Watts Bar Nuclear Plant, Unit 2
NRC Docket No. 50-391

**Subject: WATTS BAR NUCLEAR PLANT (WBN) UNIT 2 – INSTRUMENTATION AND
CONTROLS STAFF INFORMATION REQUESTS**

Enclosure 1
TVA Letter Dated December 3, 2010
Responses to Licensee Open Items to be Resolved for SER Approval
and TVA Commitments

Watts Bar 2 Common Q PAMS Block Diagram Westinghouse Class 3 (Non-Proprietary)

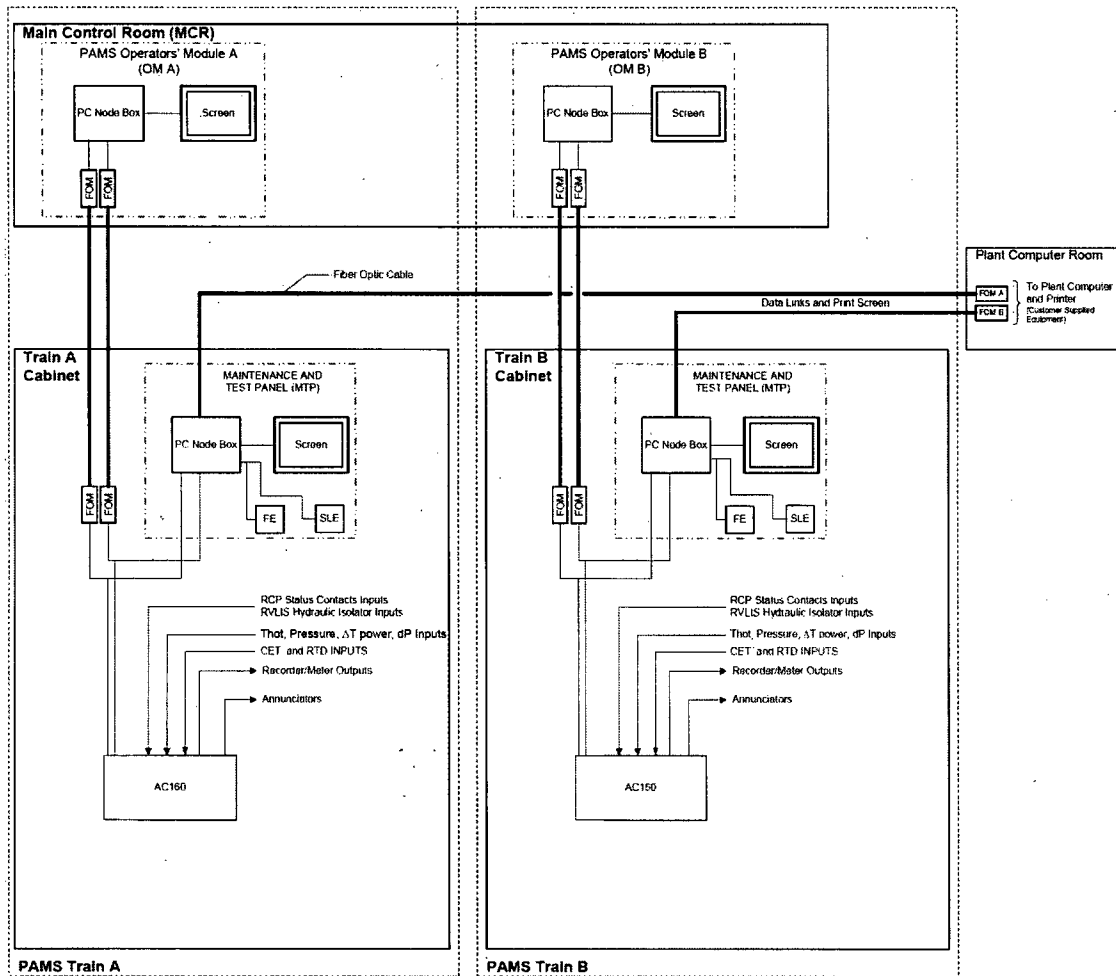
Neither of these documents contains a non-proprietary figure of the architecture that can be used in the SE. Please provide a non-proprietary figure of the architecture.

Non-Proprietary version of "Watts Bar 2 Common Q PAMS Block Diagram"
